PLANNING DEPARTMENT

## Planning Commission Staff Report

**Subject:** Treasure  
**Project #:** PL-08-00370  
**Author:** Francisco Astorga, AICP, Senior Planner  
**Date:** 14 September 2016  
**Type of Item:** Administrative – Conditional Use Permit

*The following is a portion of the Creole Height diagram from the MPD exhibits page 22.*

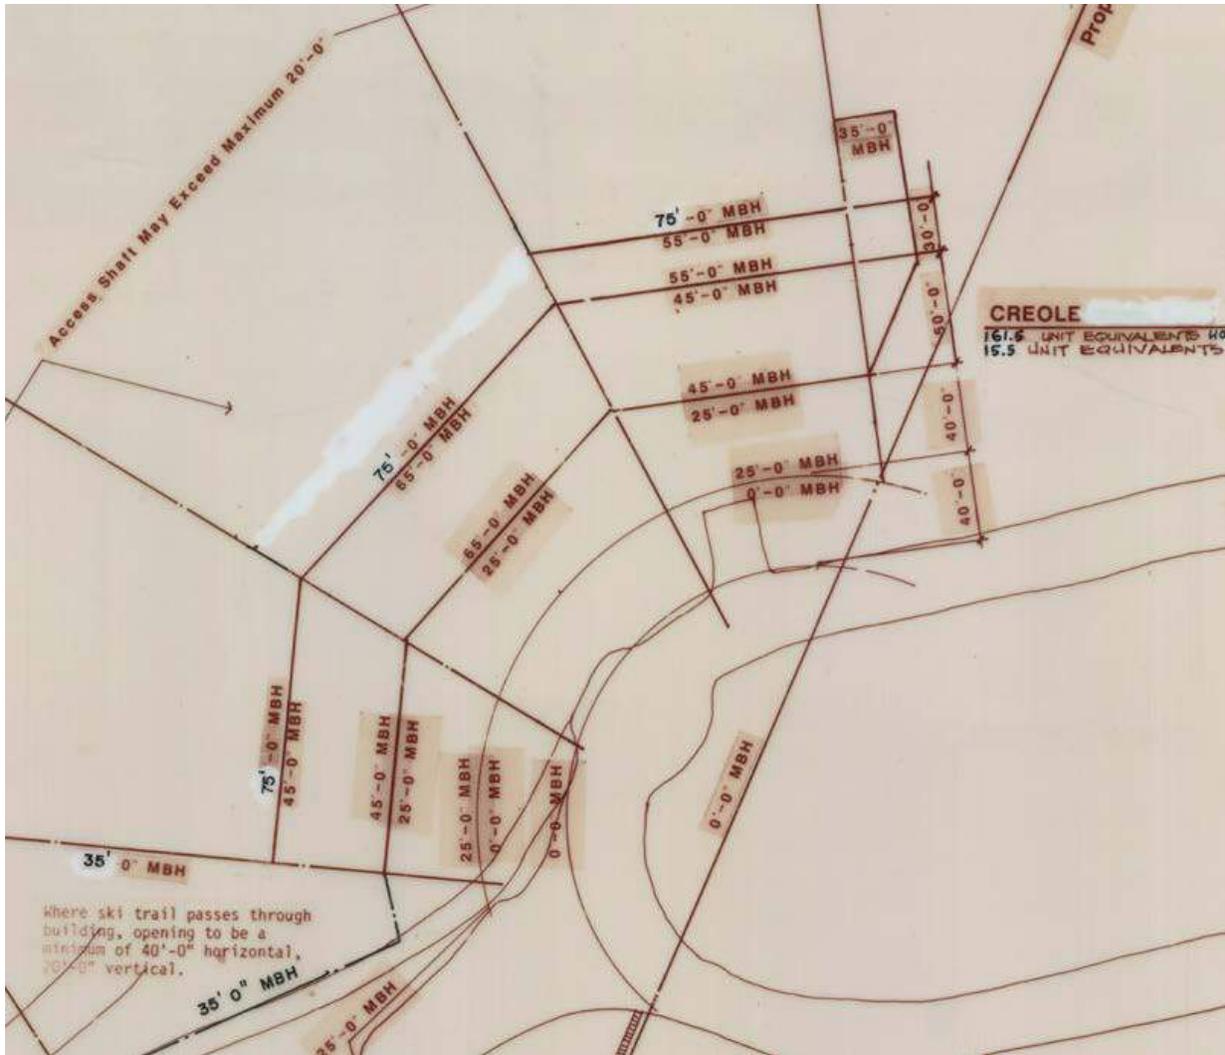
*The 1986 MPD approval set standards for increased density and increased height on the site. The MPD set height envelopes over the site which increased the allowed height from the front to the rear lot lines. The area closest to the front lot line along the Lowell Avenue/Empire Avenue switchback was set at a 0' maximum building height. The maximum building height increases in steps from the front property line. Maximum elevations were also set within the MPD. The mid-station maximum elevation was set at 7420 feet and 7275 feet for Creole. The current application complies with the height requirements set forth in the MPD, yet the design modifies existing grade well beyond the anticipated amounts shown in the exhibits of the MPD.*

*This MPD exhibits designated the areas that the buildings could be built within the development parcel. The second guiding document is the conditions of approval for the MPD in which maximum height envelopes were defined. The following is from the findings within the MPD approval.*

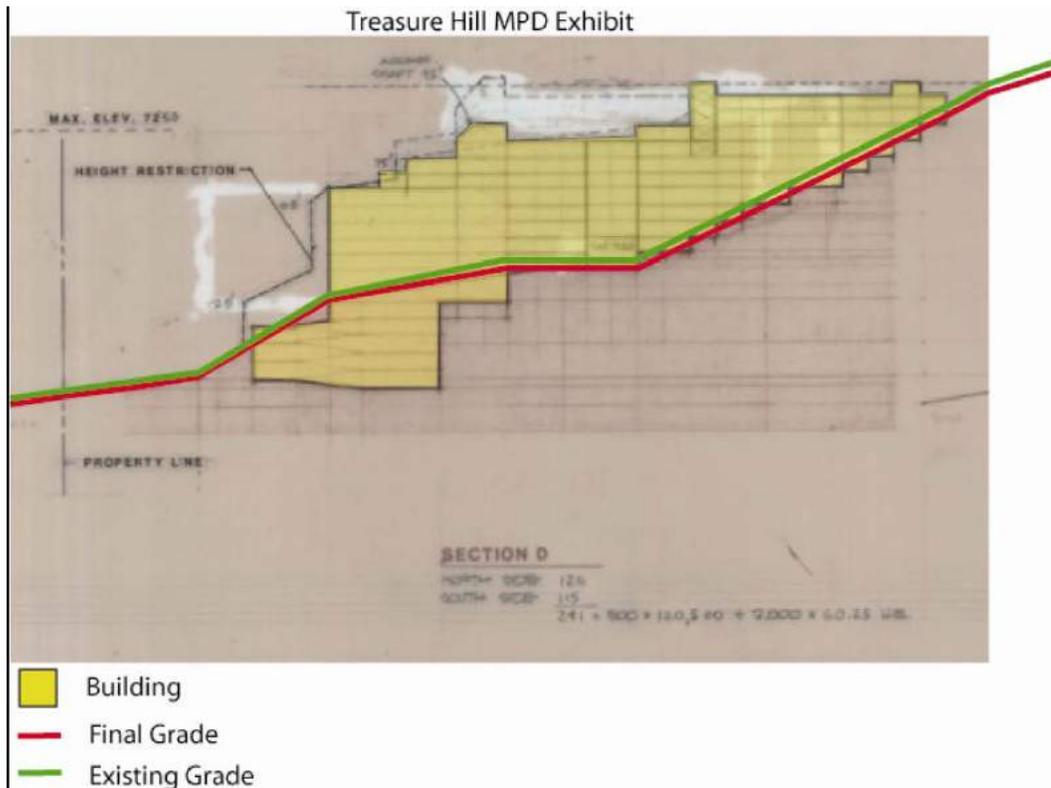
Staff finds that the excess square footage included in the project that is influencing the building massing and bulk. The building mass and bulk is also influencing the orientation of the buildings on the site. The original MPD exhibits were to be utilized as guiding documents. The following is from Exhibit 19 and is an architectural section of one of the buildings on the Creole site.

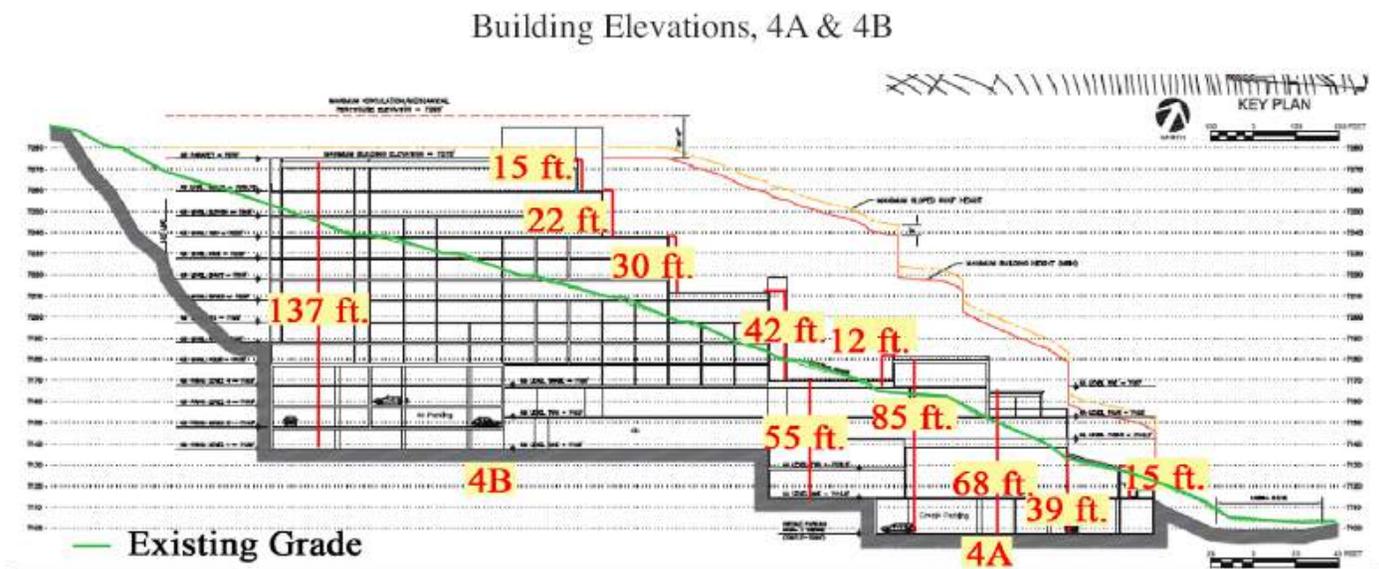
The building steps with the grade on the site and manages to keep final grade (after construction) close to existing grade (pre-construction). The majority of the area shown below grade is for the parking.

The current application places more massing and bulk below the existing grade. Not only is the massing placed below the existing grade, the grade is then altered dramatically creating taller building walls, taller retaining walls, and greater massing. The following is a section through Creole site plan of the project. The green line is existing grade. The red line is the maximum height envelope. By creating a lower final grade, the buildings appear taller and the bulk and massing becomes larger. The pedestrian walking through the project will experience higher building walls due to the change in final grade. Also, the view from other parts of town (Exhibit B) is of building with greater massing due to the change in final grade from existing.

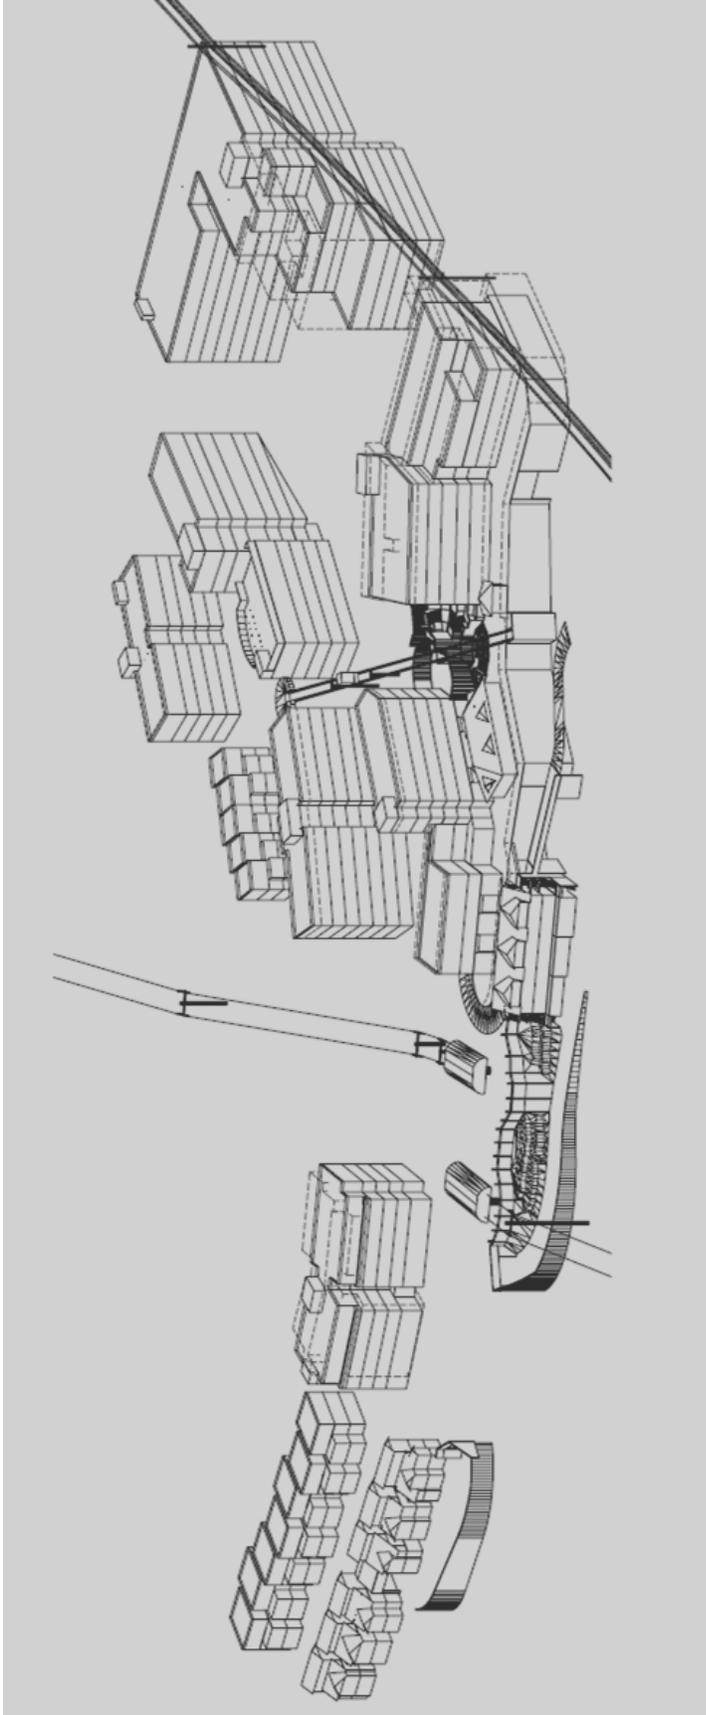
Compatibility with the surrounding structures in mass and scale must be considered within the rights of the Sweeney master plan. The master plan created an area of greater height allowances and density next to a historic neighborhood with low height and medium density. The MPD essentially created a new zone with height envelopes and greater density adjacent to the HR-1 zone, Estate zone, and open-space. The Planning Commission must find compatibility with surrounding structures within the higher density already approved.

Staff acknowledges that it will be difficult to achieve a project massing that is similar to the existing neighborhood context given the previously approved density and volumetrics set forth in the MPD. The Sweeney Master Plan anticipated the difficulty of designing higher density adjacent to the historic district. The following is from the analysis section of the 1985 Master Plan staff report:

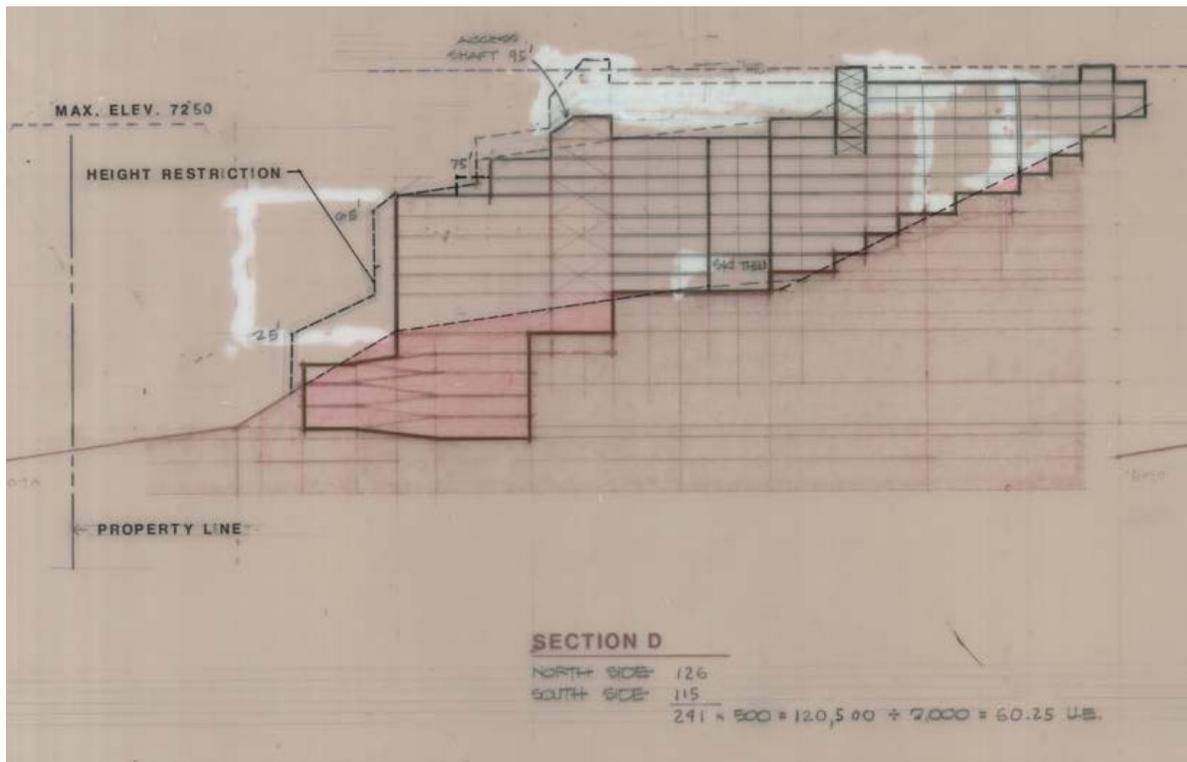
Criteria 15. Within and adjoining the site impacts on environmentally sensitive lands, slope retention, and appropriateness of the proposed structure to the topography of the site.

*The proposed design requires a very large excavation and re-grading of the entire site. The project is located on the mountain side on steep topography. The impacts to the slope and existing topography are substantial and unmitigated. The project as designed will create a very large hole on the site. The project does not step with the natural topography of the site. As discussed previously, staff finds the project as designed is not in compliance with the concept approved by the City Council during the 1986 Master Plan approval. The exhibits within the master plan showed the building volumes stepping with the existing grade with the exception on the underground garage.*

*By stepping with the natural grade, there is less excavation. The exhibits within the master plan are guiding documents. The exhibits show minimal impacts on excavation.*
